UNITED STATES PATENT AND TRADEMARK OFFICE

APPLICATION NO.	FILING DATE	FIRST NAMED INVENTOR	ATTORNEY DOCKET NO.	CONFIRMATION NO.
09/982,584	10/17/2001	Jorn von Seggern	11232	7560

Office Action Summary

DETAILED ACTION

Part of Fig. 4 of Greenwell '887

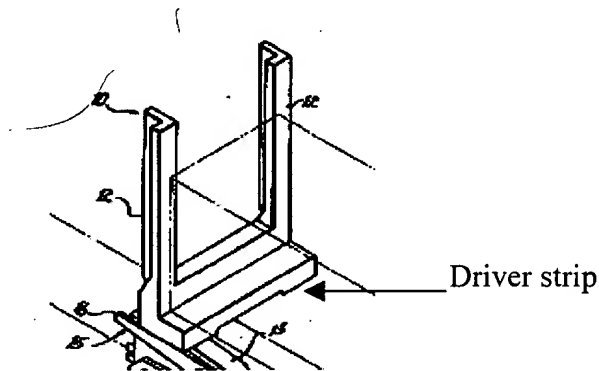
Greenwell discloses all of the claim limitations in a similar conveyor apparatus for transporting objects shown in fig. 4, the apparatus comprising a plurality of continuously circulating guided conveyor lines (20, 20a) that are constituted of chains, each line being provided with a plurality of drivers (10, 11) to contact said objects, said drivers being releasably connected (C4/L20-26) with one of said conveyor lines, so that the distance between drivers can be altered to accommodate objects of different sizes.

Greenwell further discloses that the drivers (10, 11) are held on each conveyor line (20, 20a) so that they can be adjusted in the direction of transport (C4/L23-26) and that the drivers (10, 11) connected to each conveyor line (20, 20a) are located at fixed intervals from each other (C4/L41-63).

Greenwell additionally discloses that each driver has driver strips (fig. 4) that extend across all of the conveyor lines transversely to the direction of transport.

Greenwell additionally discloses that the same number of drivers (10, 11) are arranged on each conveyor (C4/L4-8; each left-handed lug 10 has a complementary right-handed lug 11 such that a pocket for receiving an object for transport is formed)
